# UNITED STATES PATENT AND TRADEMARK OFFICE

APPLICATION NO.	FILING DATE	FIRST NAMED INVENTOR	ATTORNEY DOCKET NO.	CONFIRMATION NO.
10/730,216	12/08/2003	Wolfgang Sommer	051812-1240	2074
24504	7590	03/02/2006	EXAMINER	
THOMAS, KAYDEN, HORSTEMEYER & RISLEY, LLP 100 GALLERIA PARKWAY, NW STE 1750 ATLANTA, GA 30339-5948			SHARP, JEFFREY ANDREW	
			ART UNIT	PAPER NUMBER
			3677

<b>Office Action Summary</b>	<b>Application No.</b>	<b>Applicant(s)</b>	
	10/730,216	SOMMER ET AL.	
	<b>Examiner</b>	<b>Art Unit</b>	
	Jeffrey Sharp	3677

### **DETAILED ACTION**

Damm et al. US-5,645,386 Figure 2 (annotated). Things clearly shown in reference patent drawings qualify as prior art features, even though unexplained by the specification. In re Mraz, 173 USPQ 25 (CCPA 1972).

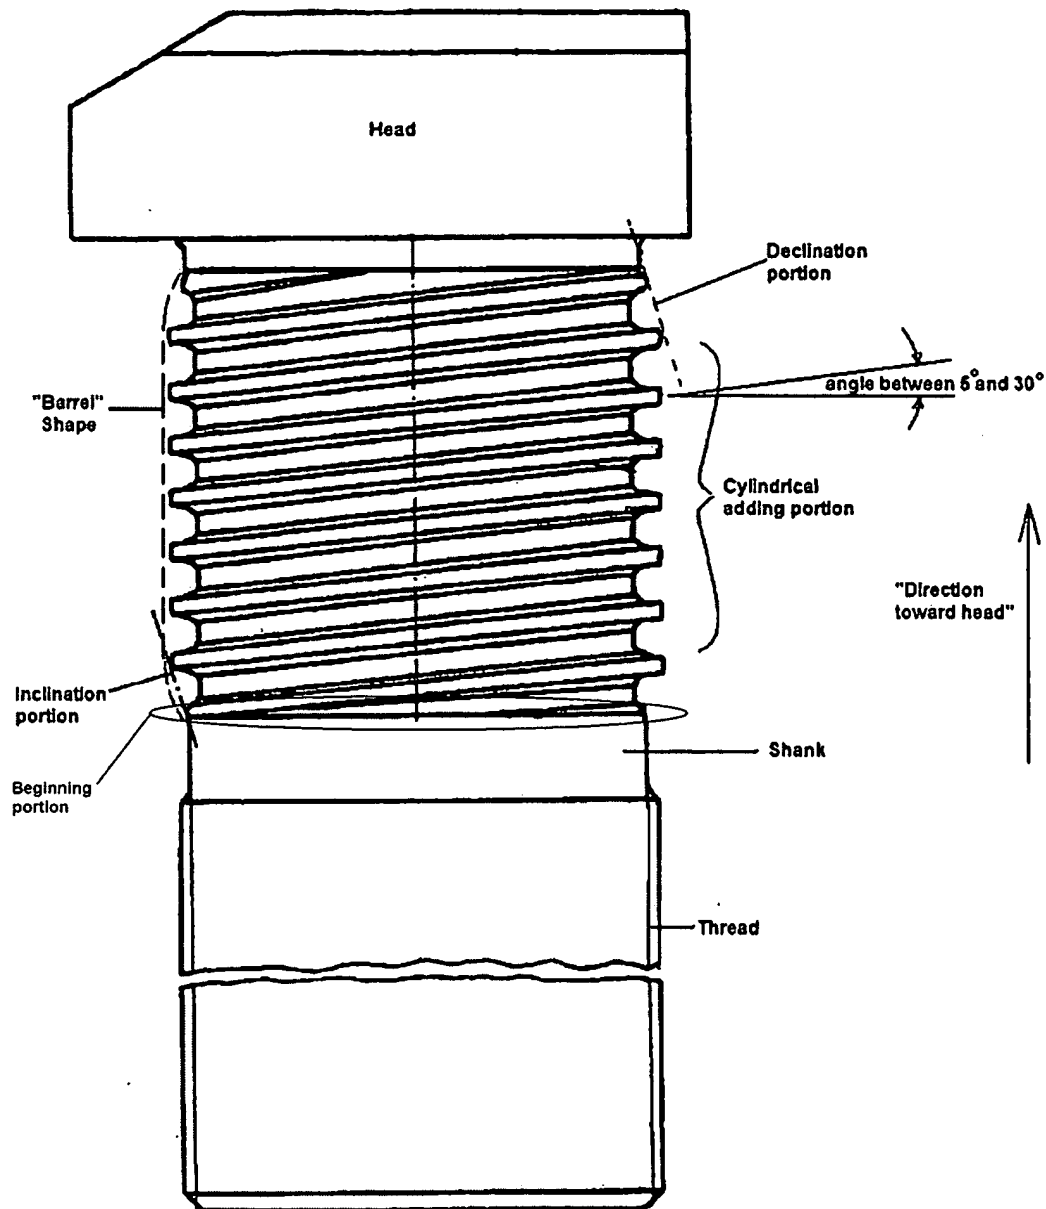
[7] Claims 1-7, 9, 10, and 15 are rejected under 35 U.S.C. 102(b) as being clearly anticipated by Damm et al. US-5,645,386.

In short, Damm et al. teaches a "wheel stud" press-fit fastener (1) having a shank (5) head (4), press-fit portion (10) having a multiple helical profile (Abstract lines 9-11), inclination portion (17), declination portion (Figure 2), "barrel-shape", cylindrical adding portion having the same outer diameter as the multiple helical profile and being next to the inclination portion toward the head, and between the inclination and declination portions.

Waltermire US-3,252,495

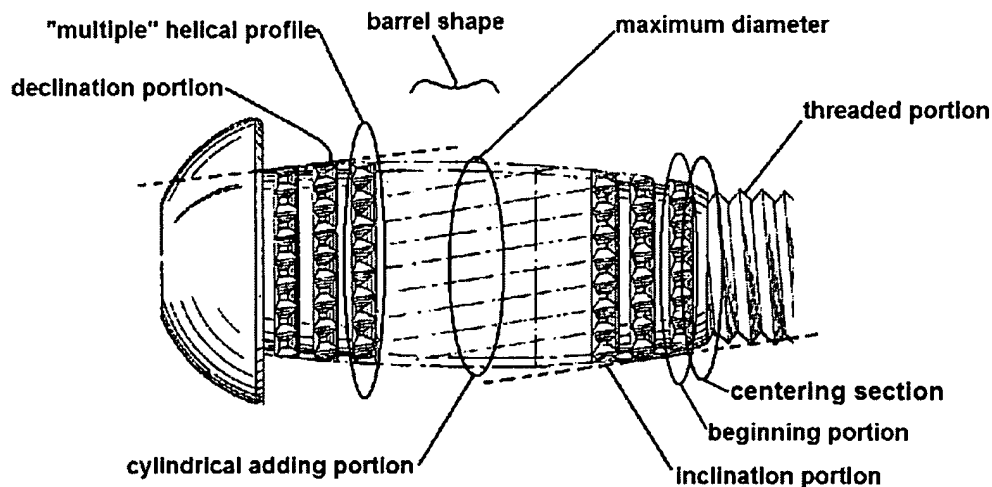
[8] Claims 1-8, and 10-13 are rejected under 35 U.S.C. 102(b) as anticipated by Waltermire US-3,252,495.

In short, Waltermire teaches a "wheel stud" press-fit fastener (10) having a shank (12) head (13), press-fit portion (11) having a "multiple helical profile" (broad interpretation), inclination portion (col. 4 lines 25-29, lines 57-65), declination portion (col. 4 lines 34-36, col. 5 lines 8-10), "barrel-shape" (col. 2 line 38), and cylindrical adding portion having the same outer diameter as the multiple helical profile and being next to the inclination portion toward the head and between the inclination and declination portions. The fastener (10) has a threaded portion (14) at a second end of the shank. The fastener (10) further comprises a "centering section" (@ numeral 12 in Figure 1) having a larger diameter than a thread of the threaded portion (14), and a smaller diameter than the minimum outer diameter of the helical profile (11). The axial length of the centering section (12) is "approximately" 10 percent that of the outer diameter of the helical profile press-fit portion (11). As for claim 8, Waltermire shows at least six threads for each (broad) "multiple helical profile".

Hartmann et al. US-6,264,414 (annotated). Things clearly shown in reference patent drawings qualify as prior art features, even though unexplained by the specification. In re Mraz, 173 USPQ 25 (CCPA 1972).

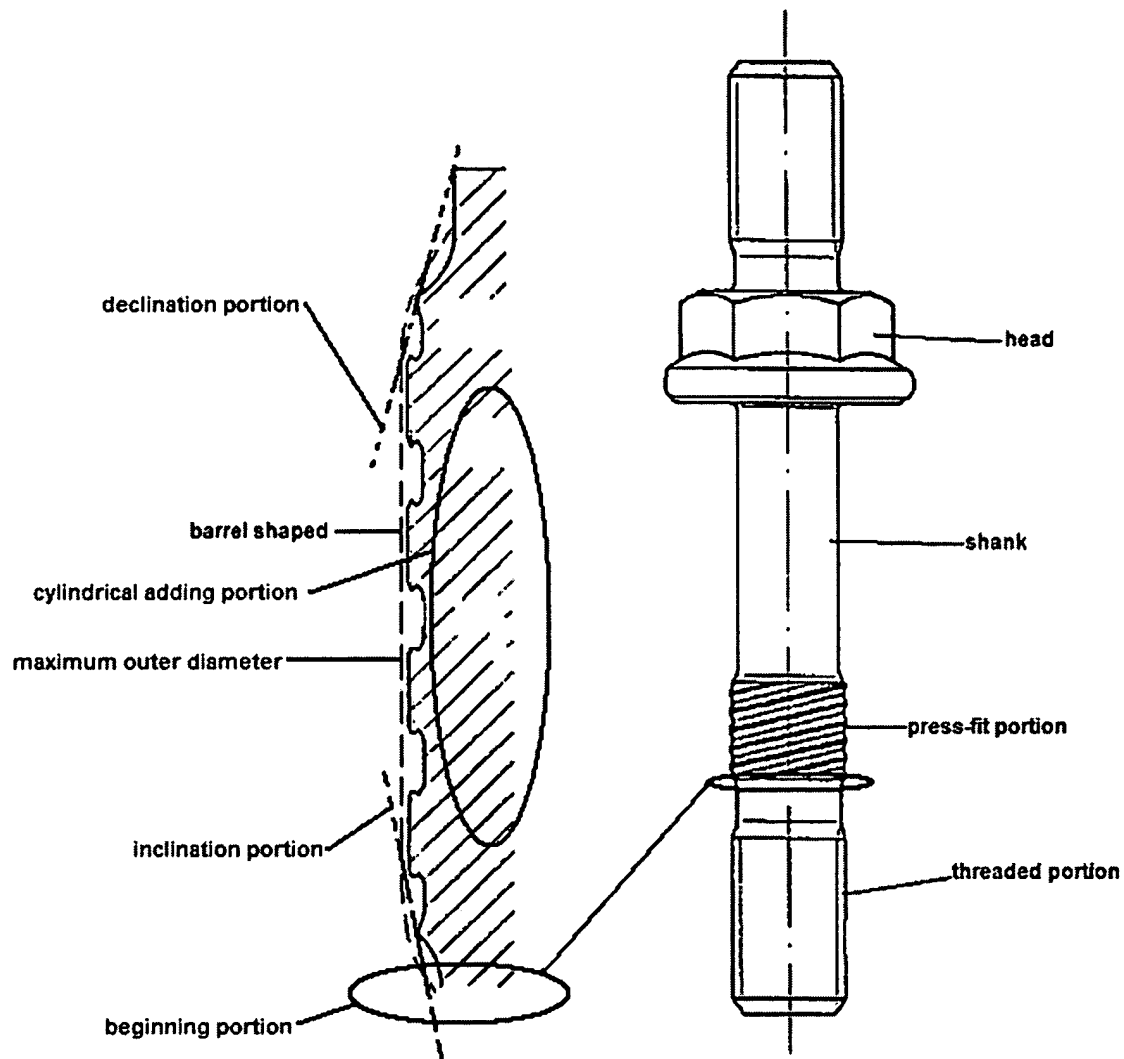
[12] Claims 1-7, and 9-11 are rejected under 35 U.S.C. 102(b) as anticipated by or, in the alternative, under 35 U.S.C. 103(a) as obvious over Hartmann et al. US-6,264,414.

In short, Hartmann et al. substantially teach or at least suggest a fastener having a head, a shank, a press-fit portion, and a thread at an end of the shank opposite the head -- the maximum outer diameter of the press-fit portion being clearly spaced apart from said head, said press fit portion clearly having both an "inclination" and "declination" portion, said press fit portion further having a cylindrical adding portion being located between said inclination and declination portions, and said press-fit portion further having a (broad) "beginning portion" adjacent the inclination portion. The multiple helical profile of the press-fit portion has "approximately" the same pitch diameter of the thread. Refer to illustration below.

Inclination portion is "designed to increase in a direction towards said head to reach a maximum outer diameter"

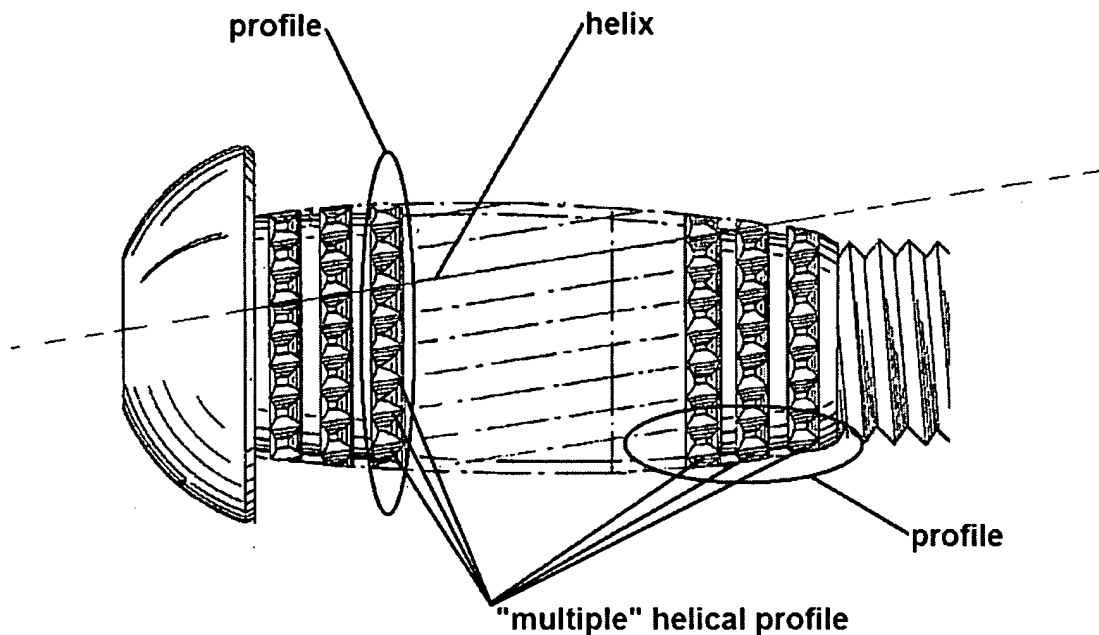
It appears that Applicant submits "*that the bottom of the alleged 'inclination portion' referenced in the [Office Action] figure could be argued to be the claimed 'beginning portion'*" (top of page 10). Therefore, when given its broadest interpretation, a "beginning portion" is reasonably taught by Damm et al. Although Applicant states that if, *arguendo*, this is the case, "*no additional claimed 'inclination portion' is disclosed by Damm*", the examiner takes the

position that *the rest of* the inclination portion (i.e., all parts of the inclination portion other than *the bottom*) could be construed as the "inclination portion".

Applicant fails to make any *reasonable* distinction between the present invention's "beginning portion" and Damm's "beginning portion". Furthermore, Applicant fails to make any *reasonable* distinction between the present invention's "inclination portion" and Damm's "inclination portion". For instance, there is no mention or limitation to the number of thread revolutions necessary in each "portion". Furthermore, there is no mentioned relative axial size limitations for each "beginning portion" and/or "inclination portion" which would lead someone of ordinary skill in the art away from Damm et al.'s teachings. The limitations are rather broad, even in light of the present specification, and therefore, are still anticipated by the Damm et al. '386 reference.
